LIDCO, Pars SEE Zone, Assaluyeh,
Integrated Methanol and Ammonia
Plant 3000 MTPD MeOH / 900 MTPD NH3 PROJECT

General Arrangement Drawing (incl foundation load details)

Document No. 17735-04

**Airpack B.V. - Air Compressor –
Integrated Methanol and Ammonia Plant
17735-COM General Arrangement Drawing (incl foundation load
details) (K020)**

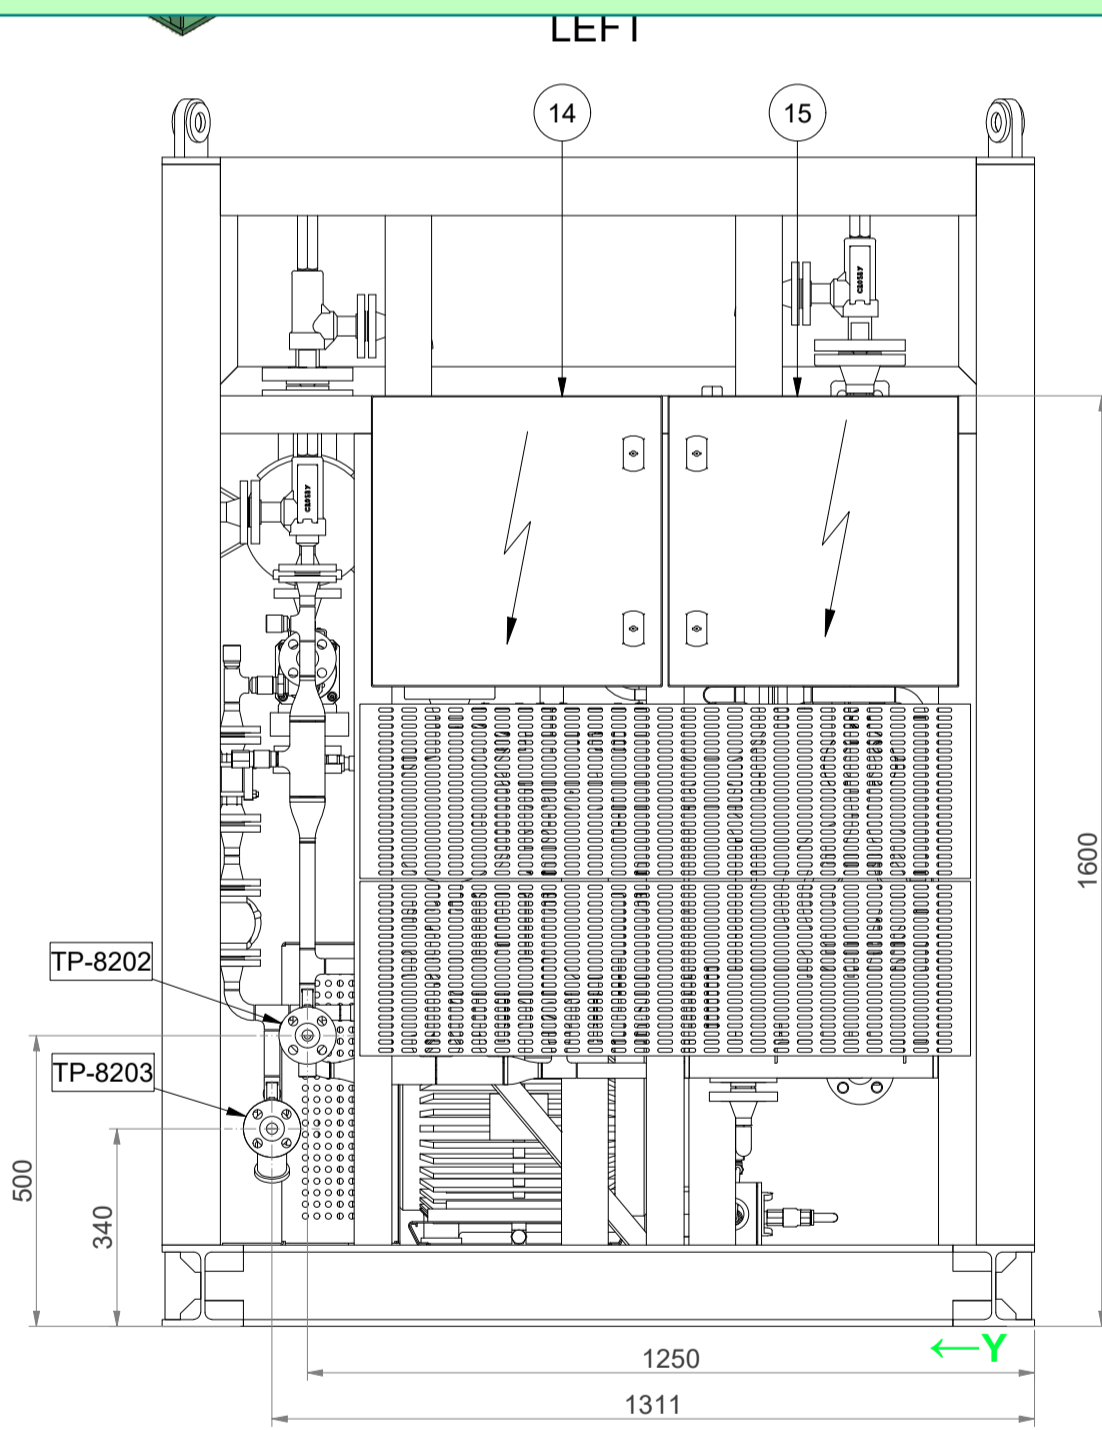
The below comment has been already confirmed on TCL by vendor so please consider it and implement it as a note or prepare reply sheet.
 - With considering this area has been considered as fire potential zone all fireproofing requirement shall be considered for equipment support, structures, valves, actuators, junction boxes and associated cable trays according to JOB SPECIFICATION FOR PASSIVE FIRE PROTECTION (N-278-000-HS-JSD-1740-00, and also the valve body shall be fire safe.
 also please note according to IEC-60331, actuators, junction box and glands shall be considered as explosion proof and cables shall be supplied as fire resistant.

foundation loading data is not complete. loading data should be completed (seismic&wind)

-Please specify Tie-in Tag No. and Nozzle dimension at this view.
 -Pipe support of lines at the edge of package where located in vendor area is by vendor

Instrument Comment:
 - Instrument Nozzle details table, Cable Tray to be indicated on this document, otherwise, this document cannot be reviewed by instrument Dept.

Please also mark item 13 (fan motor) in this view and please clarify the fan will cool which device (refer to the application of this fan?)

It seems instruments are not displayed in GAD

Please add a section for reference documents and please refer to compressor datasheet, P&ID and other major docs

According to vendor reply on VPIS, Sketch of lifting/transport arrangement will be provided as additional page on GA.

What do these dimensions refer to? (Are they related to COG?)

Please clarify if this oil pump has any PSV (positive displacement pumps require PSV for protection)

Please display oil drain of sump on GAD

Please mention/mark the port for filling the oil sump

Please also add weight of compressor, dampers, and coolers as well.

to be clarified there is V-belt

Please mention "maximum maintenance weight"

Please correct the name (there is no nitrogen)

As per latest comment PID document, tag name should be revised.
